UNITED STATES NUCLEAR REGULATORY COMMISSION

DOCKET NO: 50-275
50-323

MEETING RE: DIABLO CANYON
SPENT FUEL POOL RERACKING

DATE: WEDNESDAY, MAY 6, 1987

TOP GRIDWORK CALCULATION OF IMPACT SPRING

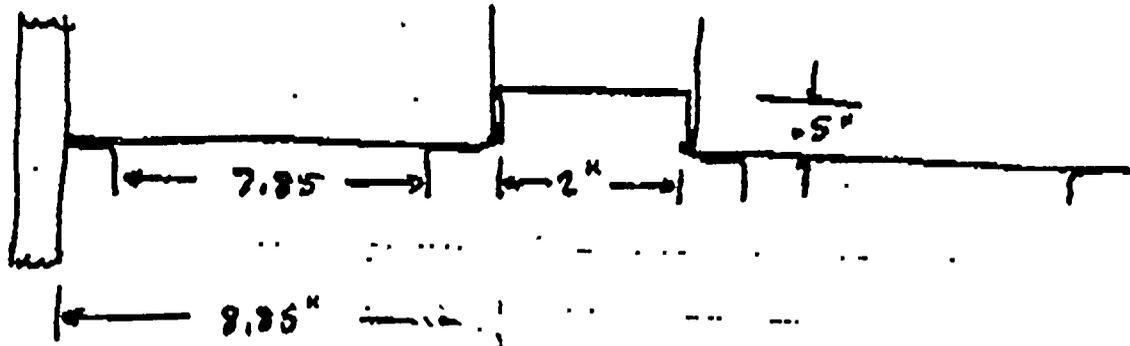
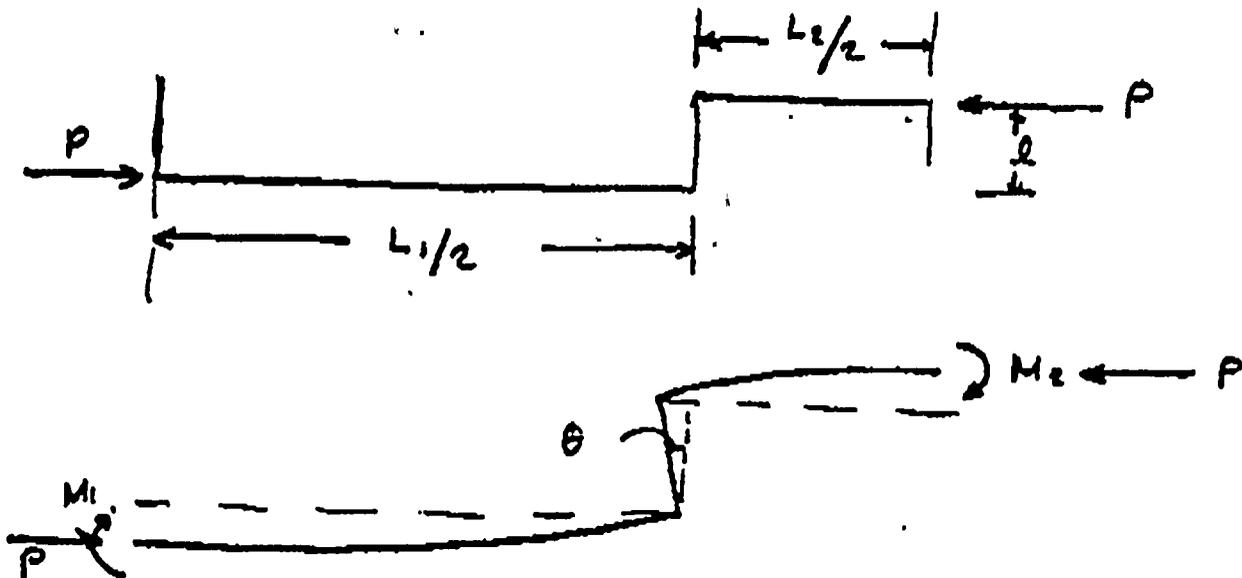
9 MR. ASCHAR: Do you have calculations somewhere
10 in the record that you will show us later on and how you
11 calculated the spring constants for the girdle bars and the
12 baseplates, the numerical values?

15 However, what I would request from PG&E is to
16 provide us with calculations for those two springs only, the
17 girdle bar spring and the baseplate.

16 The girdle bar stiffness was calculated using the
17 theory of a beam on an elastic foundation.

18 The flexibility of the gap channels connecting
19 two rows of cells were used to calculate the elastic
20 foundation modulus. The baseplate stiffness was set at
21 twice the stiffness of the girdle bar to account for in-
22 plane rigidity.

6. The following are calculations, based on the actual configuration I.O. Drawing D-7708, Rev. 5, to determine the safety margin that exists in the weld between the base plate and the upper part of the support leg.

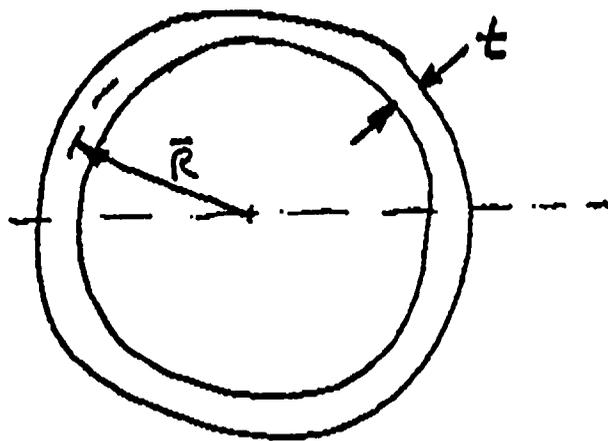
3 Provide clarification of the weld stress
4 calculations shown on page 271 of Reference 2 for the upper
5 portion of the adjustable support leg as shown in Figure
6 3.6(b) of Reference 1.

16 MR. ASCHAR: That is where our question arises.
17 What is the maximum that could be allowed by the ASME code?

6 MR. FISHMAN: As part of this question, what we
7 wanted to derive from this is, when you completed the weld
8 stress, independent of what the allowable is, what precise
9 numbers did you plug into, which formula for weld stress.

10 Figure 3 shows the classification and geometry
11 for the weld connecting the upper portion of the adjustable
12 support feet to the baseplate. The baseplate material has
13 the lowest allowable stresses. This allowable weld stress,
14 as calculated by subsection NF of the ASME Section 3 code,
15 was used in the calculations. These allowables are as
16 follows:
